[Docket No. FAA-2016-9254; Directorate Identifier 2015-CE-030-AD; Amendment 39-18948; AD 2017-14-04]

#### Airworthiness Directives; Piper Aircraft, Inc. Airplanes

**ACTION:** Final rule.

Figure 1 to paragraphs (g) and (h) of this AD: Oil cooler

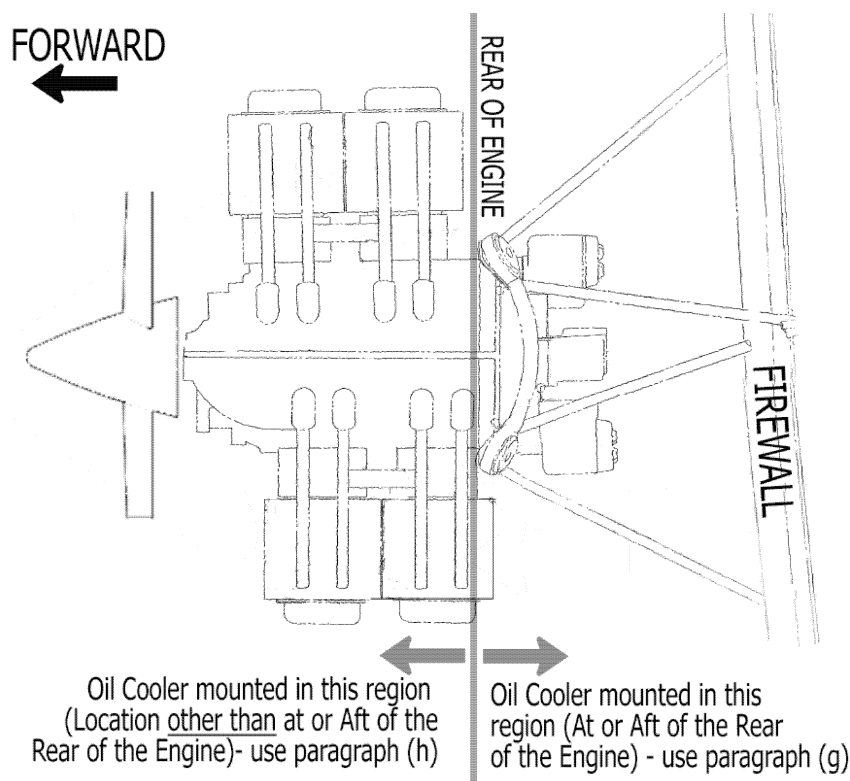
*For any oil cooler hose assemblies that do not meet TSO–C53a, Type D requirements:* Within the next 100 hours time-in-service (TIS) after February 5, 1996 (the effective date retained from AD 95–26–13), and repetitively thereafter at intervals not to exceed 100 hours TIS, inspect the fire sleeve of each oil cooler hose assembly for soaked oil, a brownish or whitish color, and any evidence of brittleness or deterioration as a result of heat or oil seepage. See figure 1 to paragraphs (g) and (h) of this AD for additional information.

after February 5, 1996 (the effective date retained from AD 95-26-13), and repetitively thereafter at intervals not to exceed 100 hours TIS, inspect the fire sleeve of each oil cooler hose assembly for soaked oil, a brownish or whitish color, and any evidence of brittleness or deterioration as a result of heat or oil seepage. See figure 1 to paragraphs (g) and (h) of this AD for additional information.

Figure 2 to paragraph (h)(2) of this AD: Acceptable clearances

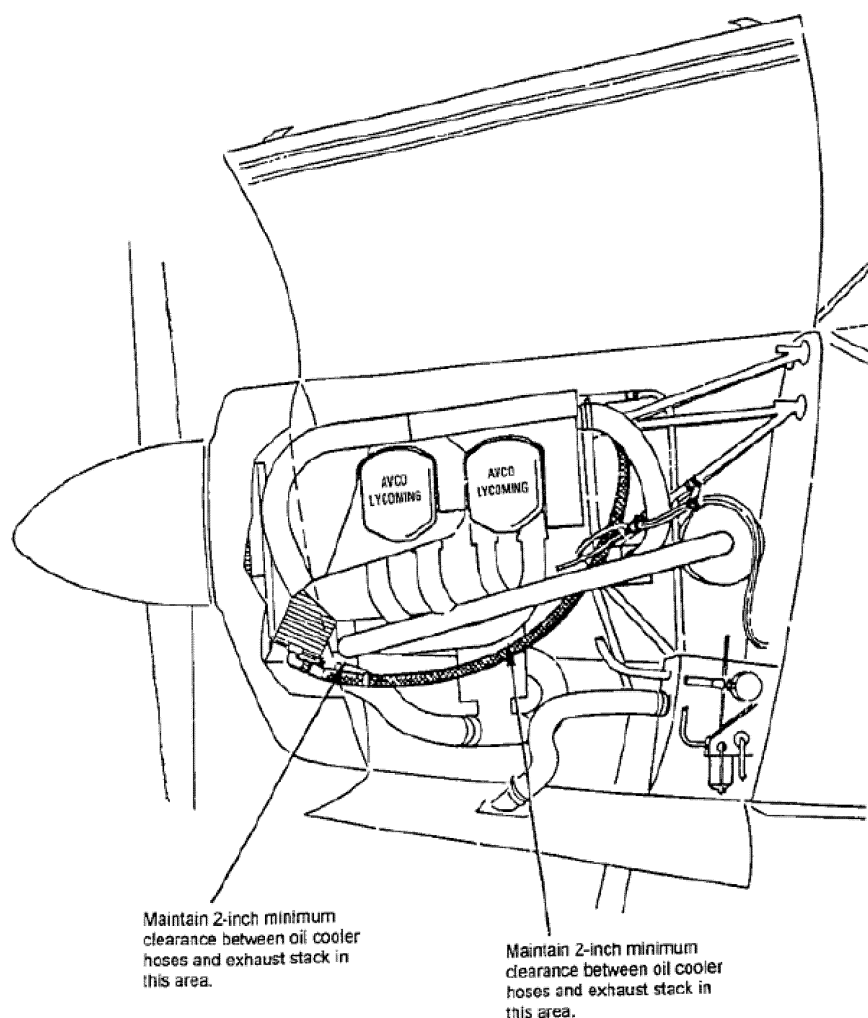
(h) of this AD for additional information. If the conditions listed in paragraphs (h)(2)(i) through (iii) of this AD are not met, before further flight, make any necessary adjustments. See figure 2 to paragraph (h)(2) of this AD for additional information.

(i) The oil cooler hose assemblies pass underneath and behind the electrical ground cable and in front of the lower of the two engine mounts.

(ii) The oil cooler hose assemblies are secured to the engine mount strut and a clearance of at least 2 inches exists between the oil cooler hose assemblies and the exhaust stack.

(iii) Oil cooler hose assemblies with a minimum outer diameter of 0.75 inch are installed with a bend radius of at least 6.5 inches.
